Seattle Slew

SUNDRY NOTICES AND REPORTS ON WELLS

Attachment to Notice of
Intention to Abandon

CONDITIONS OF APPROVAL

WELLBORE SCHEMATIC

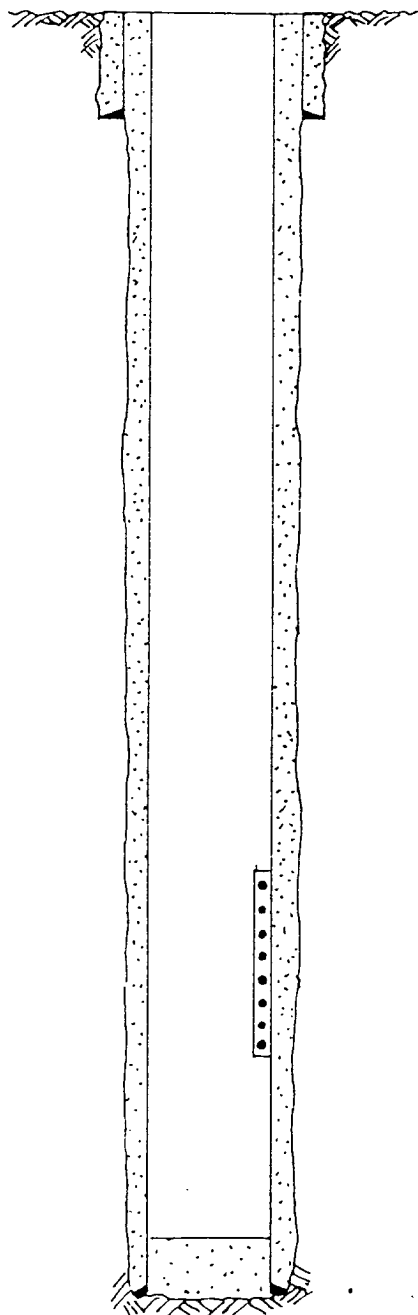
1. Plugging operations authorized are subject to the attached "General Requirements for Permanent Abandonment of Wells on Federal Leases."
2. Mark Kelly with the Farmington Office is to be notified at least 24 hours before the plugging operations commence (505) 327-5344.
3. Blowout prevention equipment is required.
4. The following modifications to your plugging program are to be made (when applicable):
